# Hardware History D424

## Mother Board 1.866.120

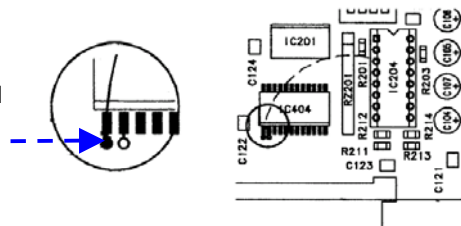
Index 25	22.6.1998 (S/N 1194	<p><i>improved clock jitter :</i></p> <p>R210: 3k3 -&gt; 1k, R226: 1k -&gt; 5k6</p> <p><i>improved TC readability :</i></p> <p>Software 120 MOTCC IC20: 1.866.915.20 -&gt; 21</p>

SCSI Board 1.866.130.24

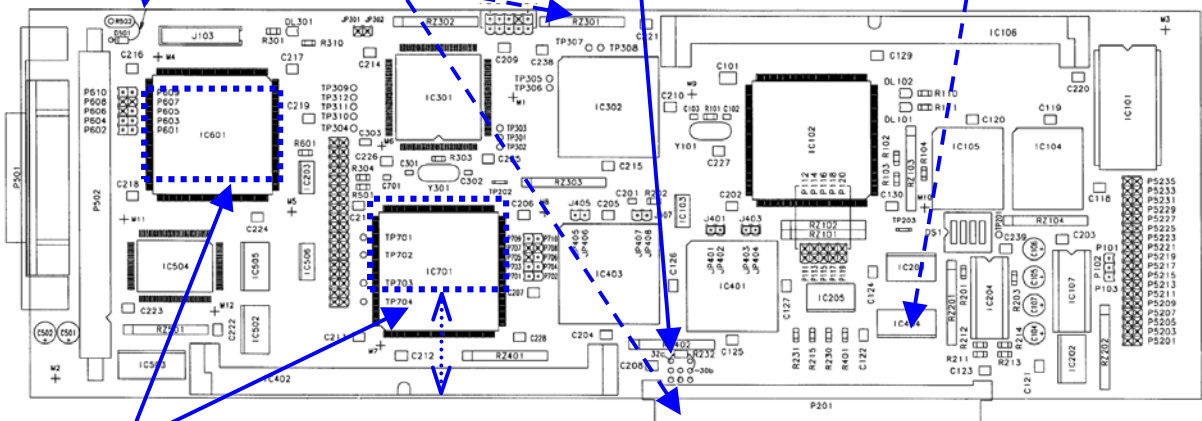
Index 26: Heatsink for IC 601/701, mounted with thermally conductive adhesive (99.01.3252)  
IC 701 : min distance to bottom edge : 29 mm

**Analog Input/Output 1.866.140**

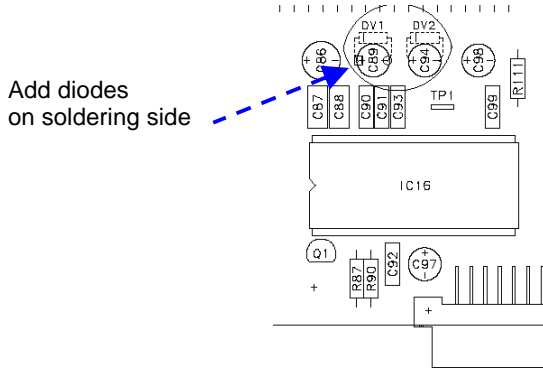
Index 20		
Rev A	22.3.2001	protection of AD Converter CS-5390 in power-up phase : - with additional zener diodes D10/11 (5.6V) in parallel to C89/C94 on soldering side

**Keyboard 1.866.160**

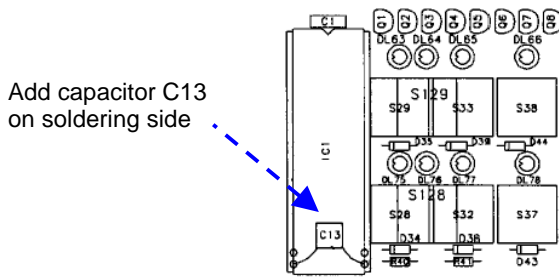
Index 00		
	8.6.1998	improved crosstalk immunity for reliable IC2 function (Key/Display I/O) with additional C13 (47pF) between IC1.20-21
